Case No. 2020-00370
Fleming Solar LLC
Responses to Harvey Economics' First Request for Information

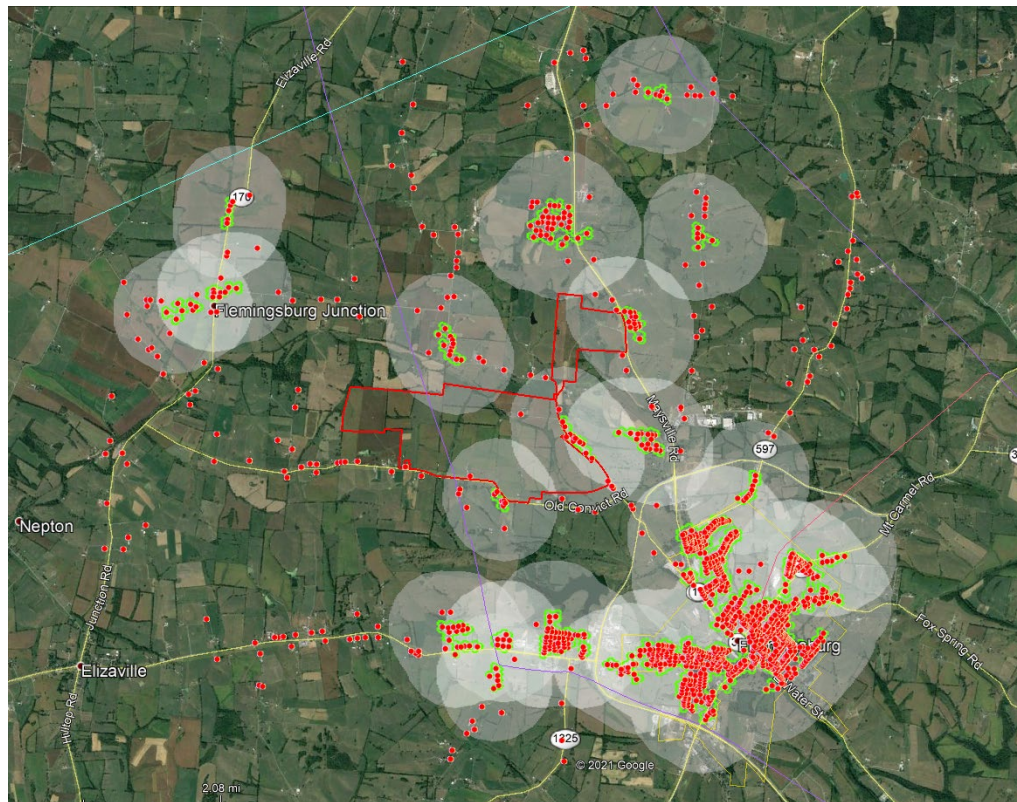
B. Could the solar panels and other structures be re-configured within the site boundaries to meet the setback requirements?

No. See figure below, which depicts a 2,000 foot buffer (white polygons) from residential areas (as defined in the statute). If Fleming Solar were to meet the setback requirements, only approximately 280 acres would be available for solar development. This project would not be feasible given the transmission line and other determining factors.

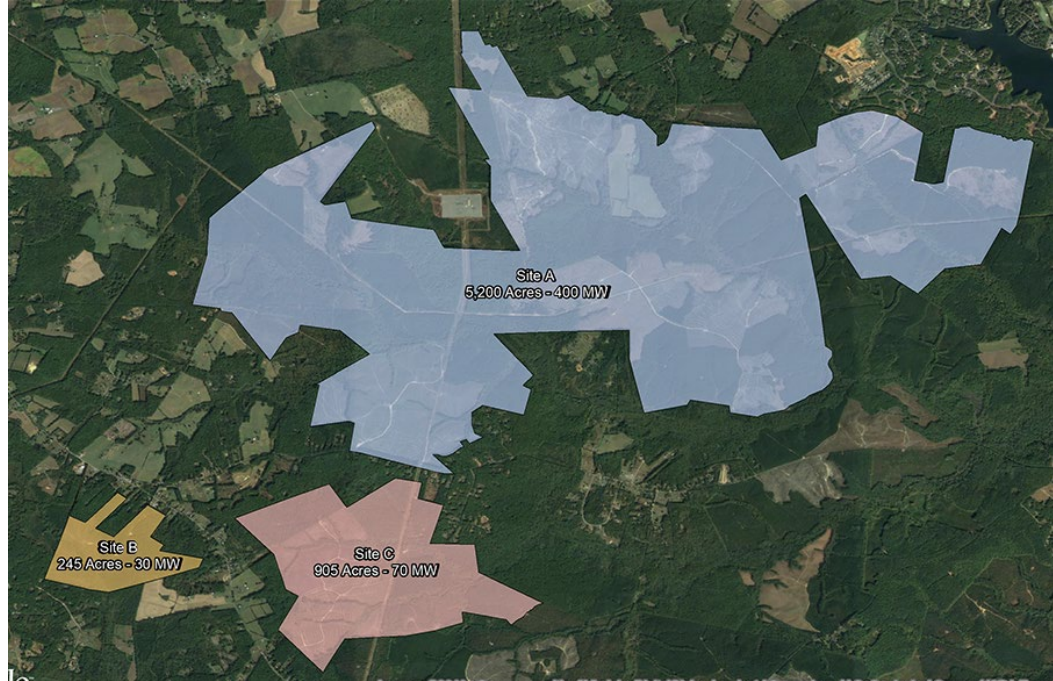
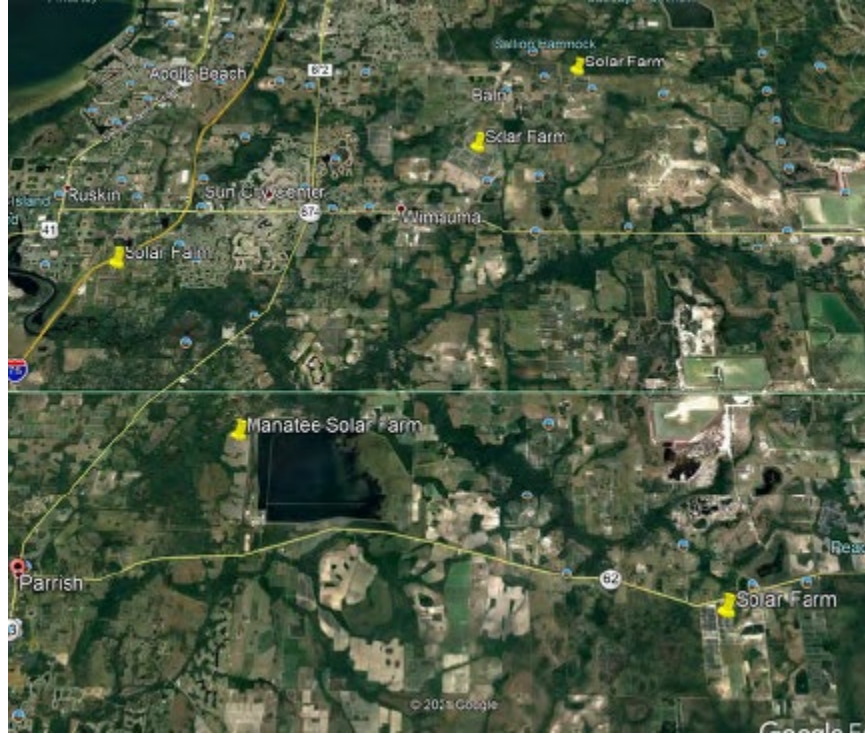
B. Has Fleming Solar evaluated the cumulative effects of the two projects on the values or land uses of nearby properties? If so, what is the effect on property values?

Fleming Solar does not anticipate there to be any negative impacts to property values or land uses due to the proximity of the AEUG Fleming project. It is not uncommon for large solar projects to be developed in phases, or for multiple projects to be sited near one another along a powerline corridor. Kirkland Appraisals included such examples in the matched pair dataset for Fleming Solar's Property Value Impact report. Fleming Solar further engaged Kirkland Appraisals to provide a specific response to this question:

"Solar farms clustered along a powerline corridor are not uncommon, and I have found a number of locations where multiple smaller solar farms were located in close proximity. Larger solar farms are less likely to cluster but they are more likely to sprawl. Because larger solar farms are developed over a wide assemblage of land and attempt to get around homes, wetlands and other features, they generally end up having divisions much like what is shown at Fleming Solar where the single solar farm is actually split into a northern and southern portion. There are many examples of solar farms where the layout of a single solar farm can be more divided and actually appear to be multiple solar farms.

The best example Kirkland Appraisals can identify is a site in Spotsylvania in Virginia. This solar farm was approved as a single solar farm, but was divided up into three sections for a combined total of 617 MW. Section C, also known as Pleinmont 1 Solar includes 99.6 MW of that total area. Maps and a full description of this project as well as the matched pairs adjoining it start on Page 47 of the appraisal report. They show homes adjoining different sections of that larger project having no negative impact on those home sales.

As another example, the 80 MW facility at Moyock NC (Page 64) has another solar farm being developed to the north east on the other side of the golf course shown adjoining that solar farm. This was approved in Currituck County after a solar moratorium had been in place for that county to establish a new solar ordinance. The first solar farm approved following the new solar ordinance was this one located on the other side of that golf course community with a finding of no impact by the Currituck County Board of Commissioners. But given the scale and the distances involved, there aren't many areas where that would really cause a single home site to be surrounded.

The Manatee Solar Farm showed no impact on property value and on Page 70. Below I have identified four nearby solar farms around the Manatee Solar Farm as shown in the map below and there is no indication that the nearby solar farms contributed to any impact on this matched pair either."
